DEVELOPMENT ASSESSMENT REPORT				
Application No.	D/2019/400			
Address	9 Phoebe Street BALMAIN NSW 2041			
Proposal	Alterations and additions to an existing dwelling including new extension and garaging, associated landscaping, pool and remediation works.			
Date of Lodgement	14 October 2019			
Applicant	David Mitchell Architects			
Owner	Ms Lisa A Wong			
Number of Submissions	23 submissions in total 1 in support 17 objections from first notification period 5 objections from subsequent notifications from people who had objected originally.			
Value of works	\$1,276,330.00			
Reason for determination at Planning Panel	Number of submissions			
Main Issues	Public and private view loss; streetscape appearance within conservation area; ; parking arrangement; stormwater drainage and number of objections.			
Recommendation	Deferred Commencement Approval			
Attachment A	Recommended conditions of consent

1. Executive Summary

Image showing location of solar panels on the roof of 11 Phoebe with the existing dwelling at 9 Phoebe in the background.

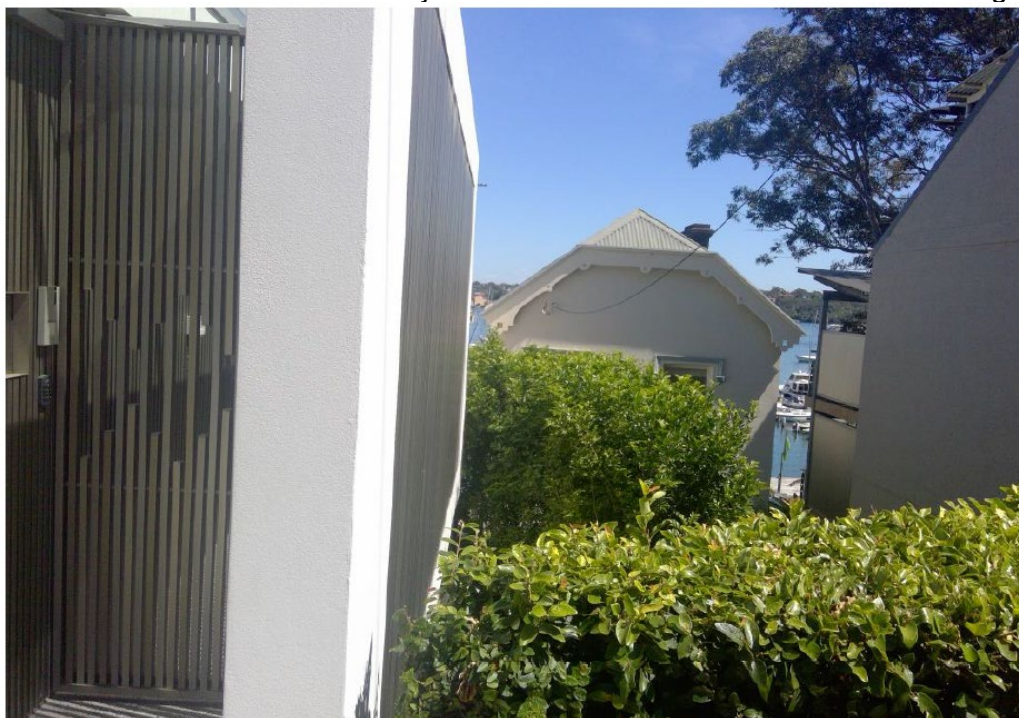
No.11 Phoebe Street has an extensive solar panel installation on their roof however between one quarter and one third would be overshadowed in whole or part between 9am and approximately 11.00am at 21 June which would accordingly impact on their operational efficiency. It is noted however that for the greater part of each day during the greater part of the year shadow impacts on the panels would be marginal.

Photo montage provided by architect for Issue B plans showing garage

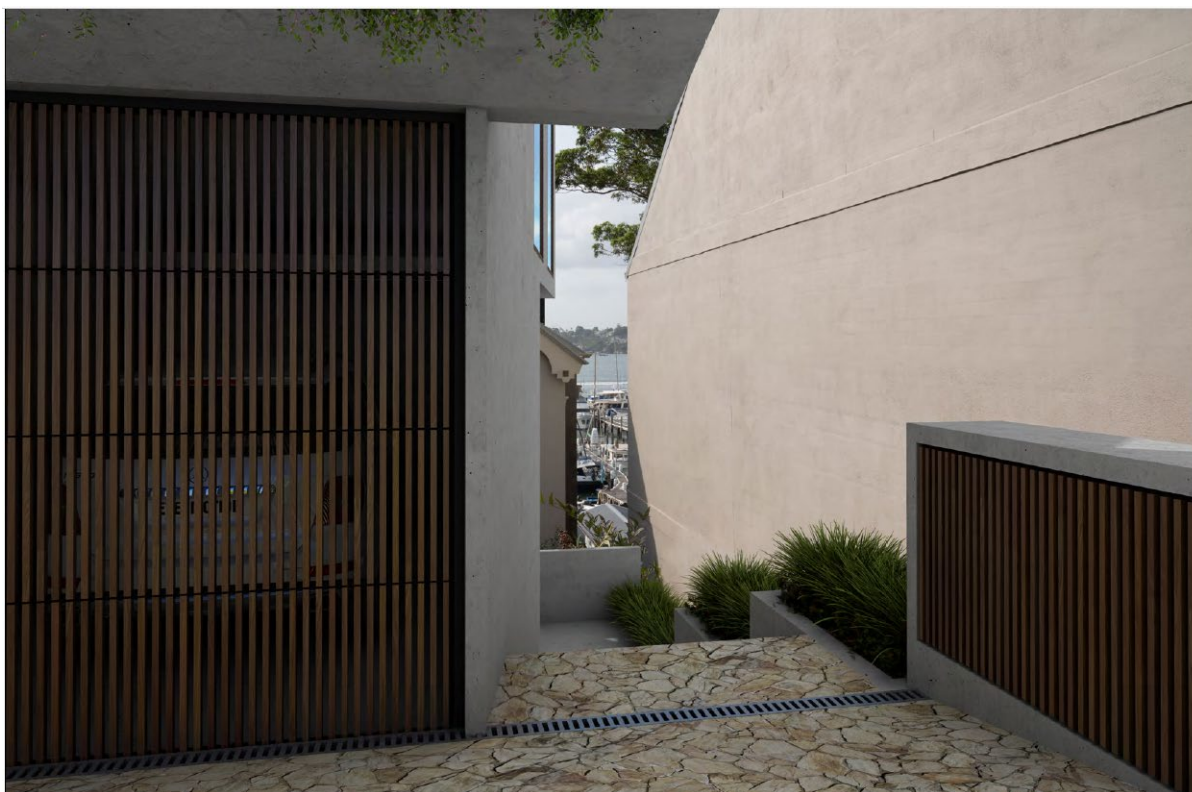
Currently the site principally has public views along the eastern side boundary of the property. The proposal will result in the loss of some public views to the water and there will be some private view loss as well.

It is noted that conditions are recommended to reduce the level 2 width and the planter box above the garage therefore the view impacts would be slightly less than shown in the photomontage. Overall, the proposal is considered acceptable with regard to the objectives and controls in relation to C3.10 – Views.

DESIGNED BY: MR & MRS ERIC AND LISA WONG
 DRAWING NO: DA 1103
 DATE: 07.05.20
 DRAWING SCALE: C

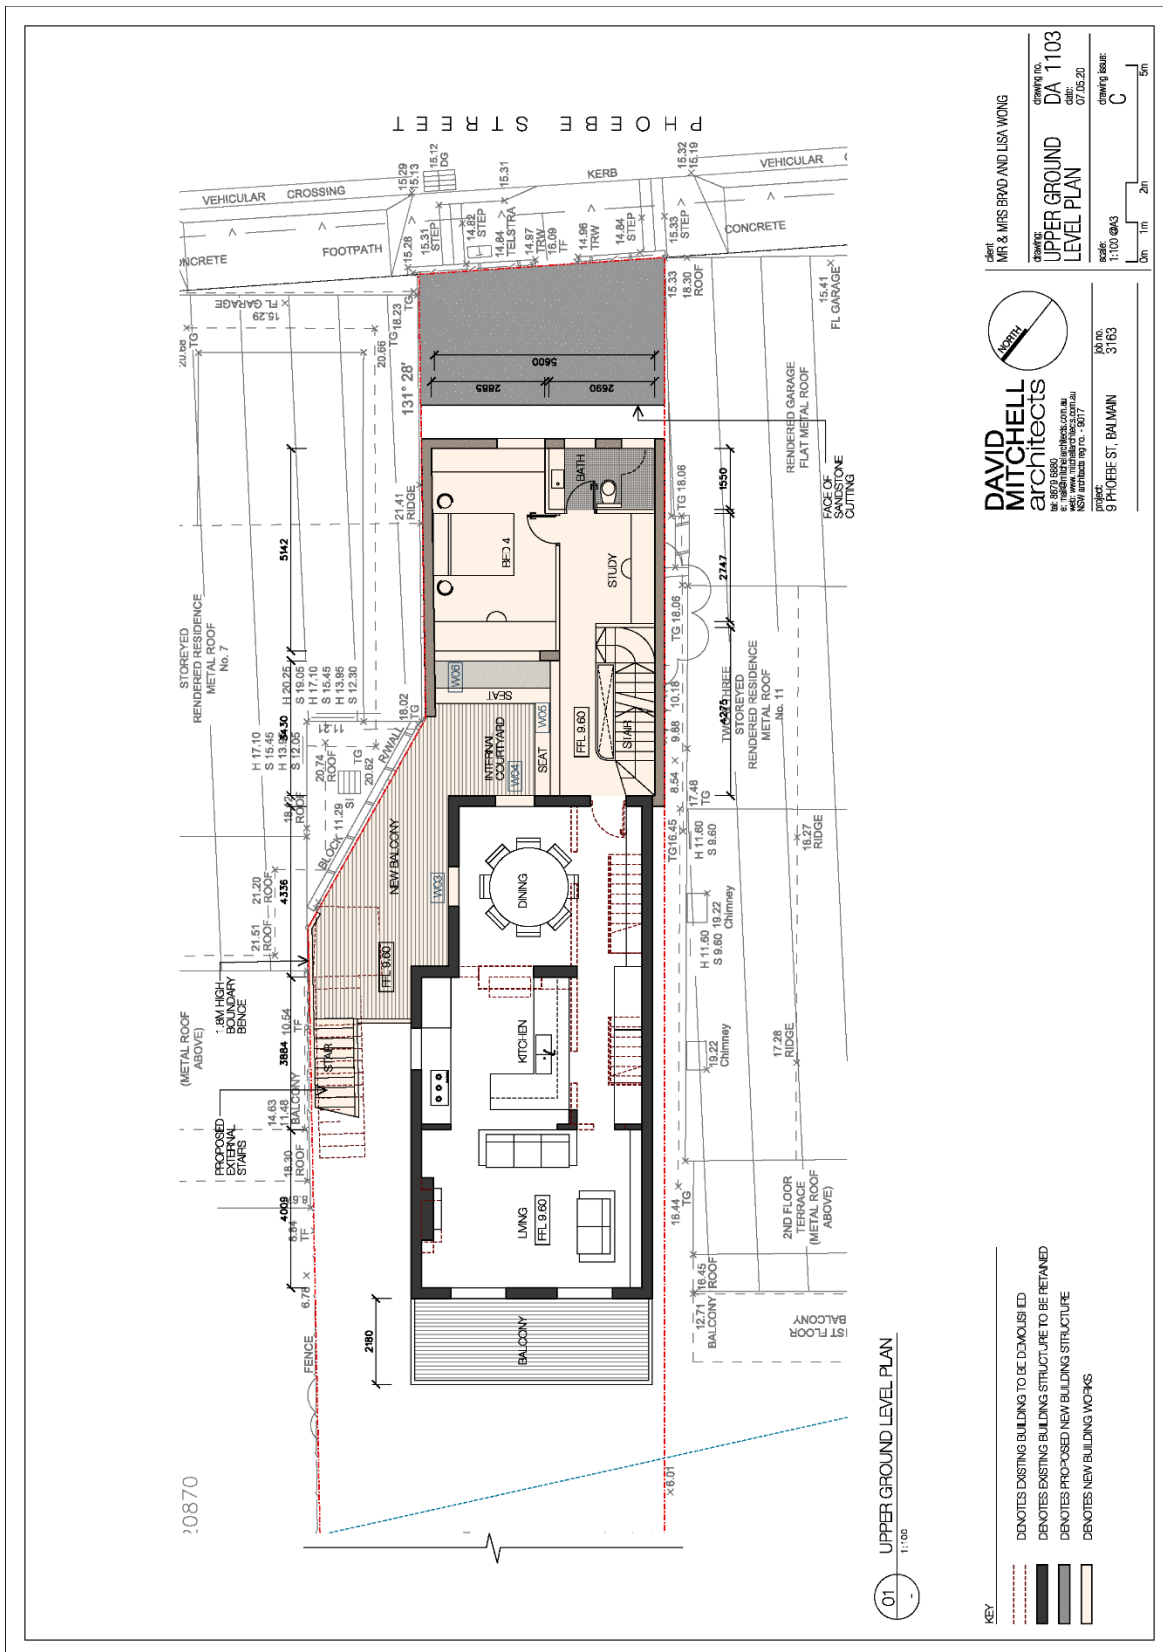
Prior to the issue of a Construction Certificate, the Certifying Authority must be provided with amended plans indicating the erection of a privacy screen on the splayed eastern side of the upper ground level balcony having a minimum block out density of 75% and a height of 1.8 metres above the finished floor level of the balcony and located within the site boundary of No.9 Phoebe Street.
